Subject: [EXTERNAL] CCPU Comment Letter - Creating a Tecolote Park/Community Connection & SDTRC Re-Zone/Retaining Recreational Opportunities for Older Communities

Re: Comments on draft Clairemont Community Plan

This correspondence serves to comment on the draft Clairemont Community Plan Update (CPU) distributed for public input in May 2021. I am providing this letter on behalf of the property ownership (Merlone Geier) for the Clairemont Town Square site. We would like to express our appreciation and general support for the goals, policies, and guidelines in the draft CCPU. Merlone Geier has been engaged in the draft CPU process and hopes to continue to engage in the CPU process and support the City's CPU efforts.

FIGURE 2-19: CLAIREMONT TOWN SQUARE - HEIGHT AND MASSING CONCEPT

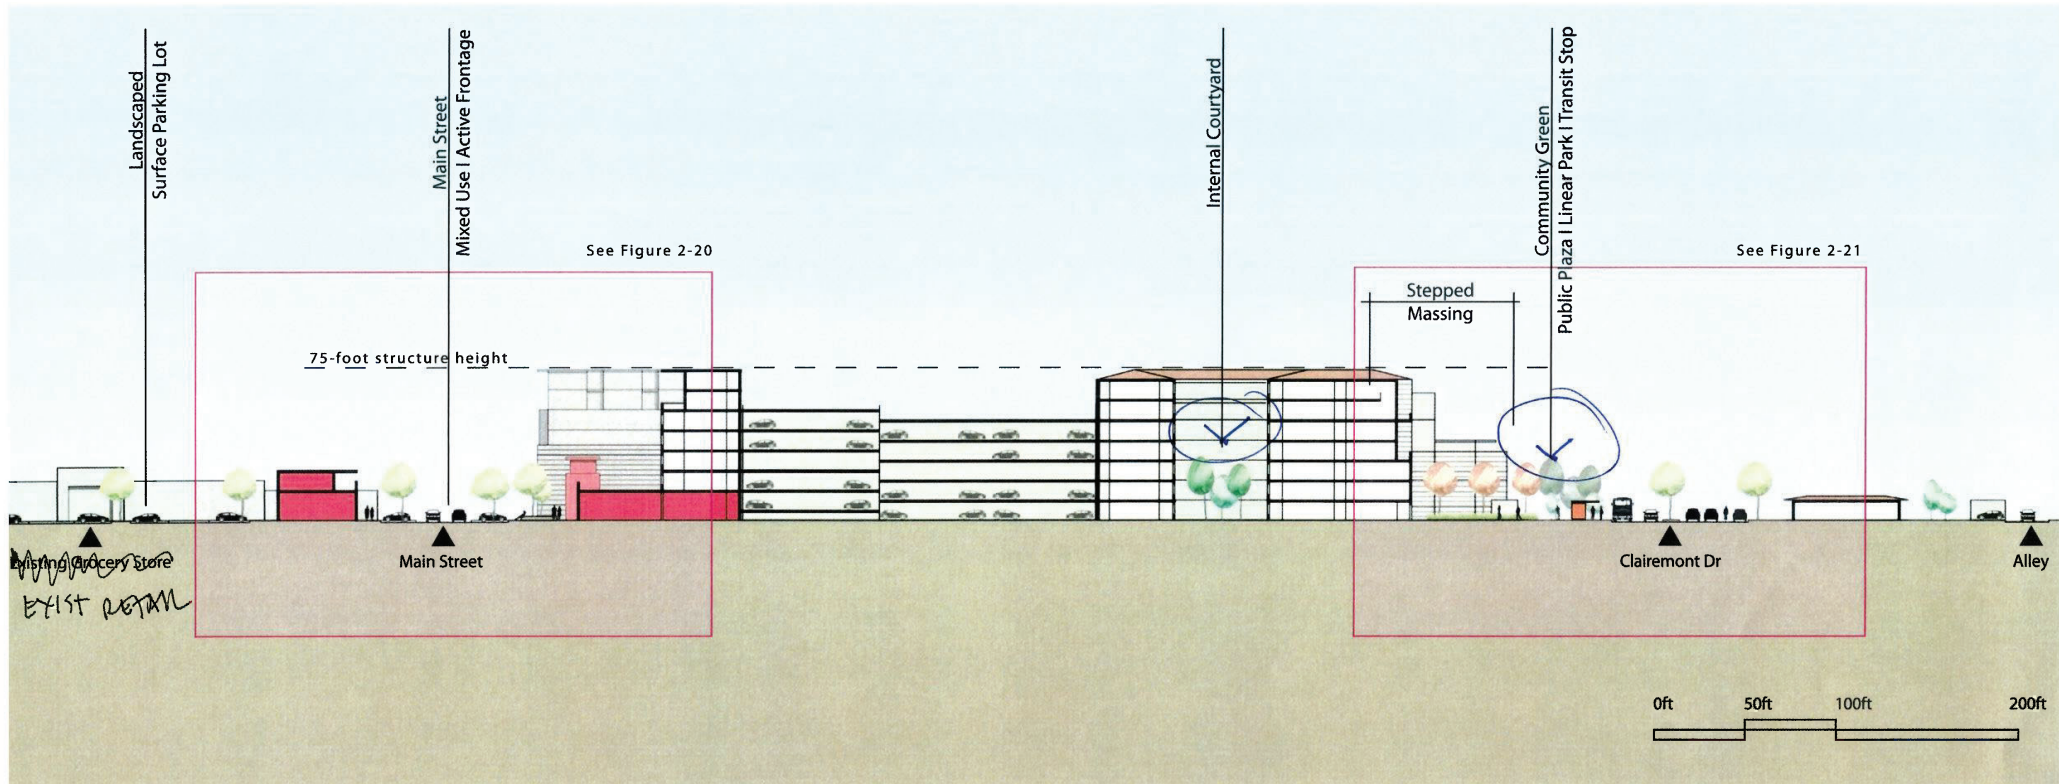
Figure 2-19:

- Please revise the language on the left side of the figure to state “Existing **Retail**” where it currently says “Existing Grocery Store”.
- Please revise the “Internal Courtyard” and “Community Green” section lines to add an arrow pointing downward.

FIGURE 2-20: CLAIREMONT TOWN SQUARE - MAIN STREET CONCEPTUAL CROSS SECTION

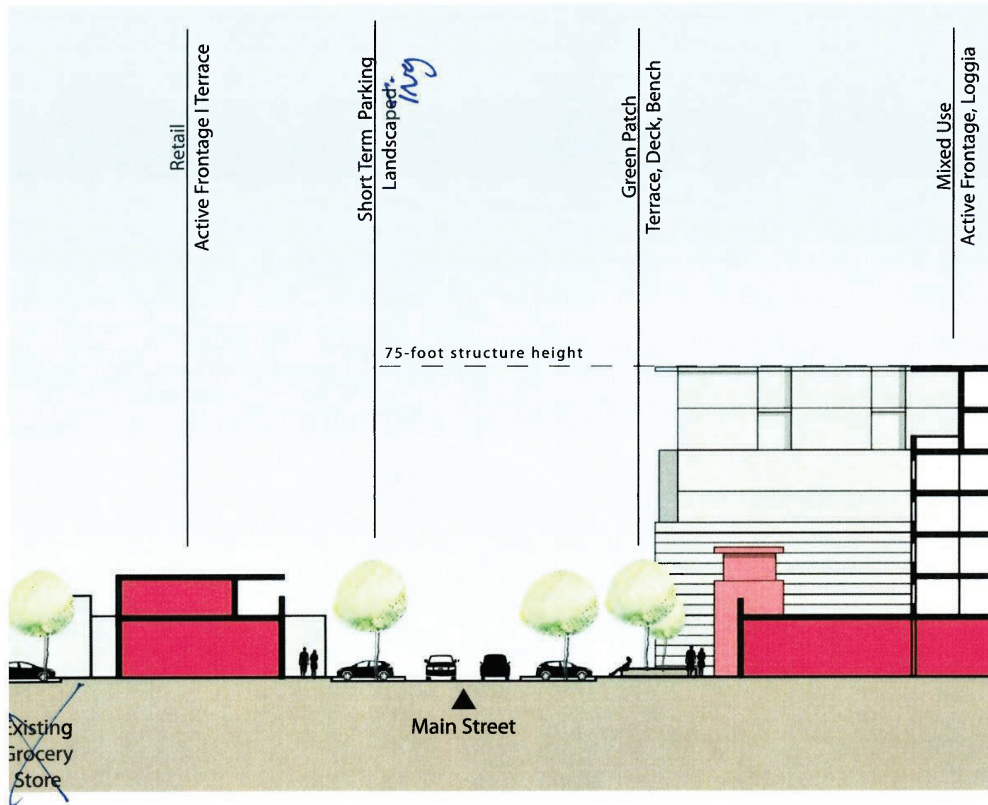
Figure 2-20:

- Please remove the “Existing Grocery Store”.
- Please revise the text along the section line to state “Landscaping”.
